DATE: December 5, 2023; 10:45 am – 11:30 am

WORK IN PROGRESS: Installation of replacement stone; Repointing of stone

End of Field Report No. Five

Photo #12: A guardrail with handrail is needed along the south side of the main entry steps. (Photo taken May 2018)

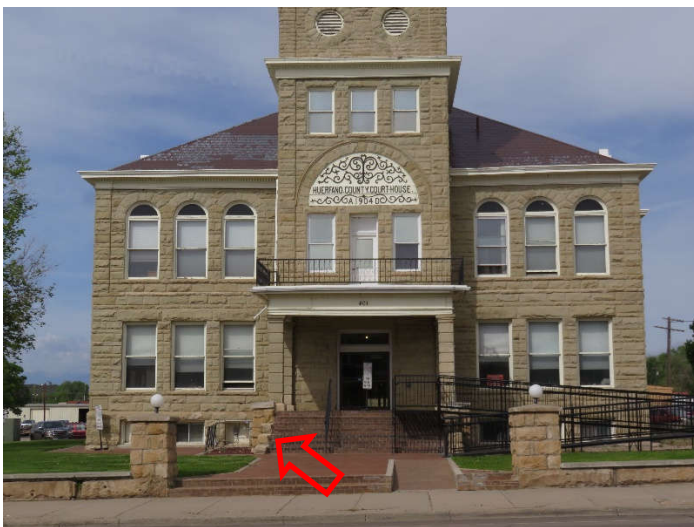
10. In addition to the need for guardrails on the north and south sides of the main entry landing, a guardrail with handrail is also required along the south side of the steps in order to meet current building code requirements. (Re: Photo #12.) Once the south cheek wall is constructed, the architects will take measurements for the new guardrail, pending Carl Young's approval of the addition to the scope of work. Like the guardrails at the main entry landing, this addition will need to be paid separately from the SHF grant.
